## Santiago Creek Plat 1 – Major Preliminary Plat

**Request:** Preliminary Plat Approval of a Major Subdivision Plat

## Santiago Creek Plat 1 Preliminary Plat

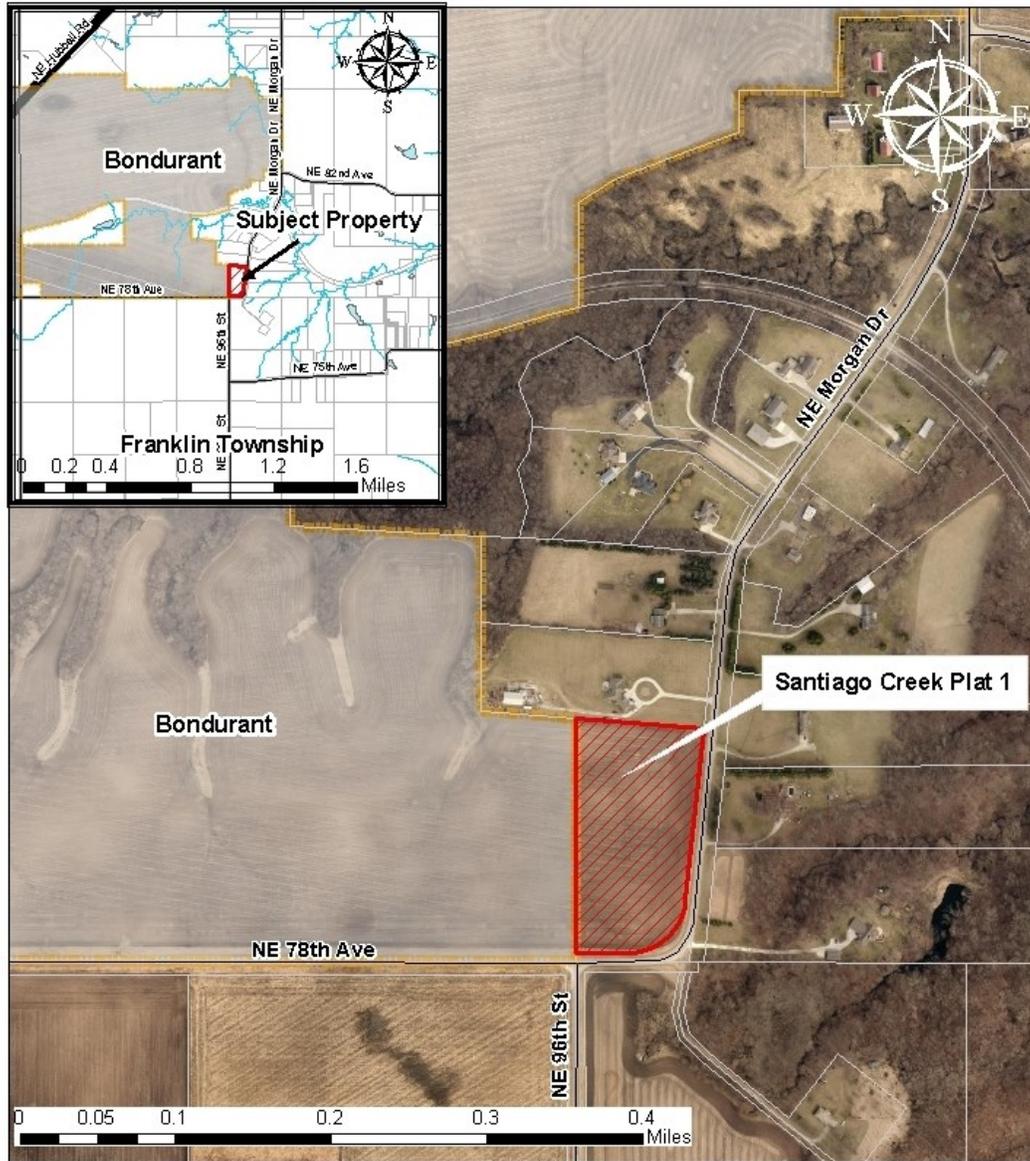
Staff has reviewed this plat for compliance with the Polk County Zoning and Subdivision Ordinances as a major subdivision plat submittal. The plat is considered a major subdivision due to the number of lots created in the ¼, ¼ Section and the requested waiver. Lot density, dimensions, frontage, access and potential waivers have been reviewed. Pending approval, re-submittals will be needed in order to address staff comments. At this stage, the commission's action would affirm, deny, or amend the overall plat layout. The current layout would require a waiver from the block length requirement.

The staff review took into careful consideration the intersection of NE 78th Avenue and NE 96<sup>th</sup> Street and the potential for a future street extension to the north. Whenever possible, intersections on one side of an existing street shall intersect with existing intersections on the opposite side of the street. There are constraints for future development in this area, including existing topography, woodlands and FEMA Flood Zone along Santiago creek to the north and northwest of this location. These constraints limit the ability to make significant future street connections, and make this intersection less viable. There are no current north south streets in this area due to these constraints. The existing homes adjacent across NE Morgan drive are estate lots similar to the proposed development, further supporting the requested proposal without street extensions to the west.

Staff recommends approval of the Preliminary Plat of Santiago Creek Plat 1, as well as the requested waiver to the maximum block length standard. The limited options for future street connectivity in this area due to the constraints identified above provided support towards the waiver request.
